URGENT SAFETY CORRECTIVE ACTION

**Sysmex XN-Series: Erroneous Automated Eosinophil
Count Discrimination**

Product Name : XN-10 and XN-20 (Cat Nr. AP795756 and AE797961)

Figure 1: Correlation data between XN and XE (reference analyzer) using the SW 00-20(Build9) and the SW version 22.07-00

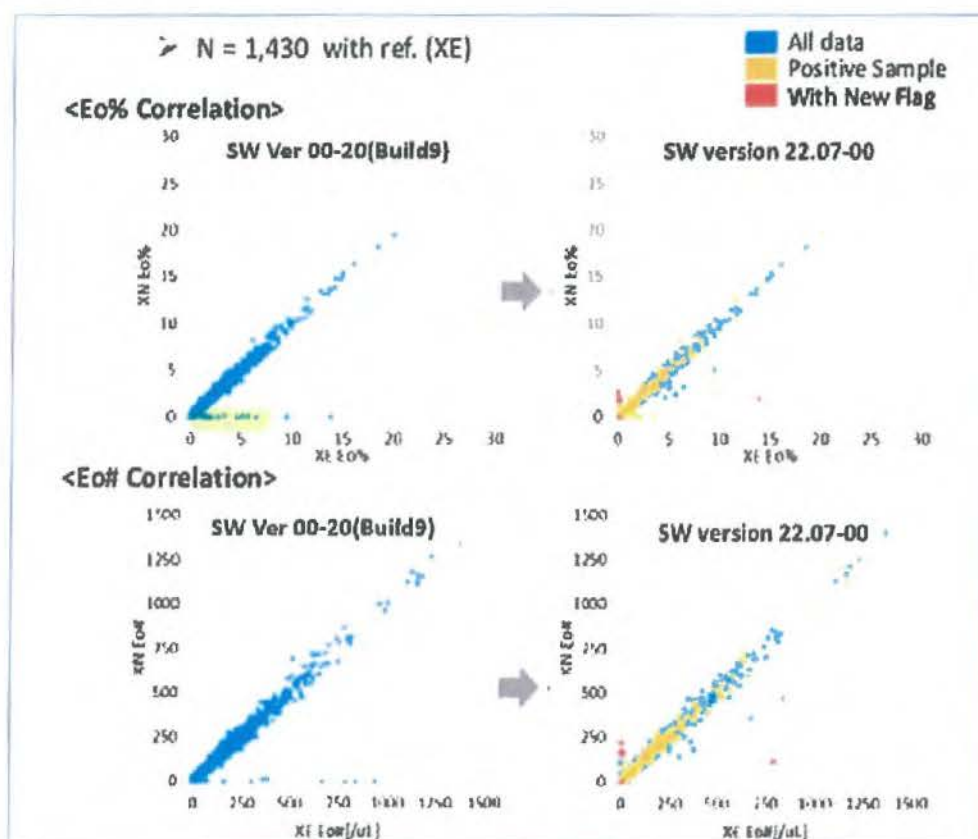
With software (SW) version 22.07-00, Sysmex has improved the algorithm that discriminates degranulated eosinophils, for better differentiation between the neutrophil and eosinophil clusters. The improvement from the original version 00-20(Build9) to ver. 22.07-00 is illustrated in the Figure 1 and Table 1:

Incidence of Erroneous Eosinophil count:
N=11 (0.77%)

Incidence of Erroneous Eosinophil count:
N=7 (0.49%)

Improved detection rate: 36.36% (4/11)

Figure 3: Screenshot of service setting on XN SW version 22.07-00 on selection of setting to mask of analysis result with misclassification for WBC differentials (0: Do Not Mask, 1: Mask)

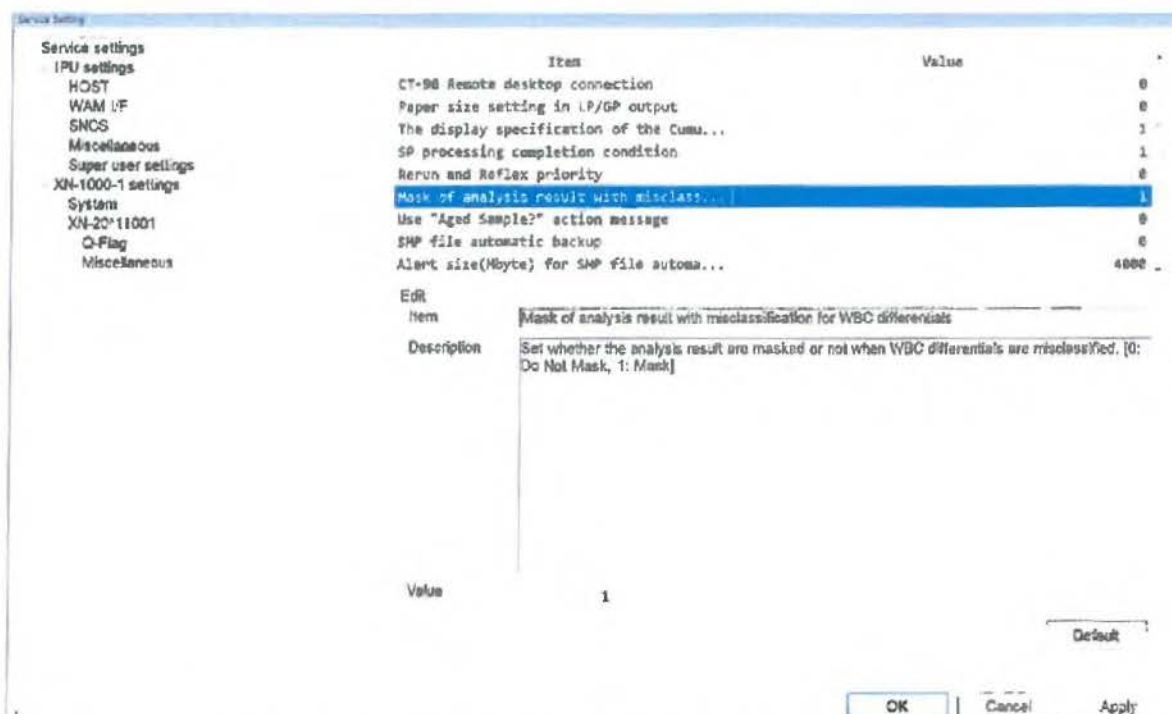
In cases where discrimination is deemed unreliable, an IP message, "WBC Abnormal Scattergram" and an Action message, "Confirm eosinophil and neutrophil count by other method" will be displayed and the sample will be judged POSITIVE. The customer has the option to mask the results (—) or mark with an asterisk to indicate unreliability, refer to figure 3 and 4 for screenshots of above mentioned settings:
